Placer County Community Development/Resource Agency
Attn: Steve Buelna
775 N. Lake Blvd.
Tahoe City, CA 96145

The Friends of the West Shore (FOWS) appreciates the opportunity to provide comments on the Proposed revised architectural design for the Homewood Mountain Resort (HMR) Project. As the County is aware, FOWS is party to a Settlement Agreement (SA) with HMR. The SA, which allows FOWS to comment on future project-level reviews, amended aspects of the approved HMR Master Plan and otherwise relied on the project as analyzed in the Final EIS and approved by Placer County on 12/6/2011 ("Alternative 1A" in the FEIS). The HMR building design was not modified by the SA as the approved design was acceptable to FOWS and its members.

Proposed architecture:

Figure 10-13A. Scenic Viewpoint 4 of North Base Building C (Residential) – Alt 1A.

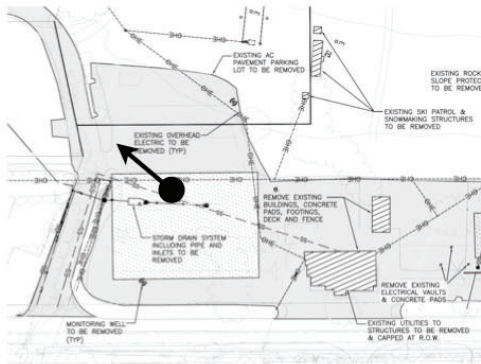
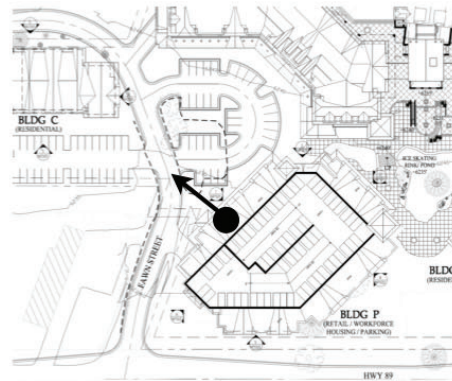
- Building Heights and Setbacks included a roof pitch of 6:12 and proposed height of 37' (p. 3-48).
- The scenic analysis analyzed impacts from Scenic Viewpoint 4 showing building C (on the "Fawn Street parcel) based on a specific architectural design (p. 10-24).

- Scenic improvements to address existing deficiencies in the scenic quality of the project area include "Design and Construction of buildings with a cohesive architectural theme that complements the natural landscape and setting of HMR..." (p. 10-42). The FEIS also shows images of the entire HMR village reflecting a cohesive architectural theme (p. 10-21).

Drawing Title: Exterior Elevations

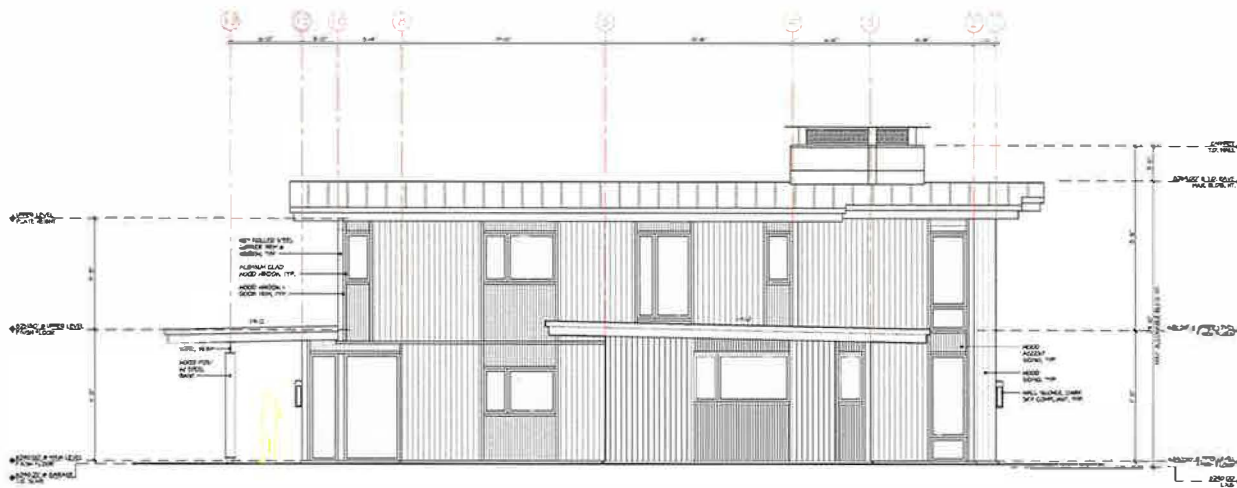
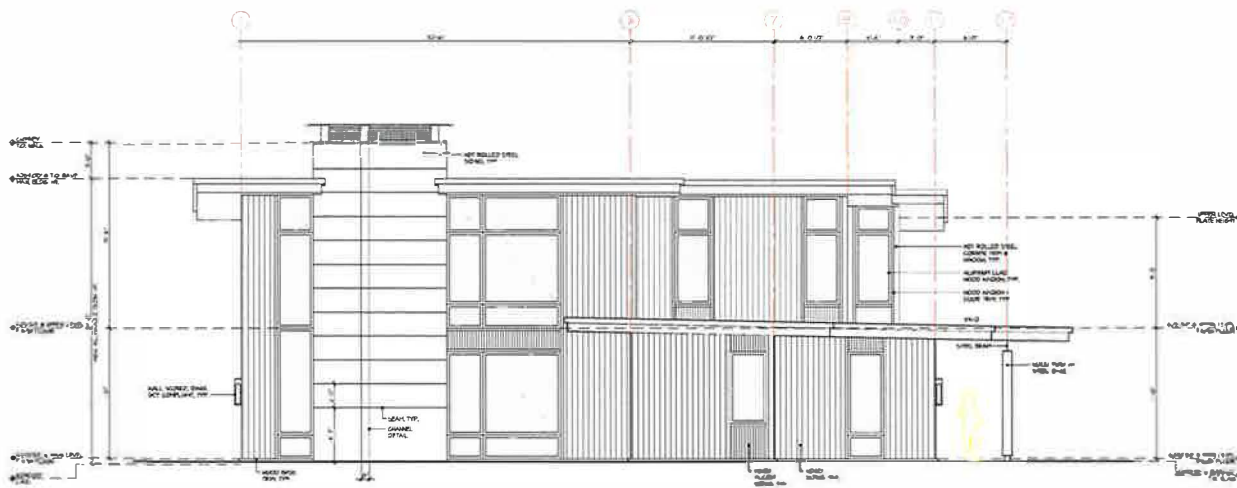
The proposed revision brought before the DRC includes relatively flat roofs (the plans provided by HMR are too blurry to discern the specific roof pitch, however it is clearly well below 6:12), a lack of architectural features such as gable and hipped shaped roofs, and does not exemplify the architecture of the Tahoe Tavern, Ehrman Mansion, and other buildings referenced in the project videos, photos, depictions and in the Master Plan. Plans and images are attached.

1. Have a public meeting to review and evaluate the new modern design and also update the community on the current status of the development in general. It has been ten years since the Master Plan approval and there has been little, if any, widespread advertisement to community members of this change.
2. Modify the proposed design (primarily to provide a roof pitch) to conform with the approved Master Plan.
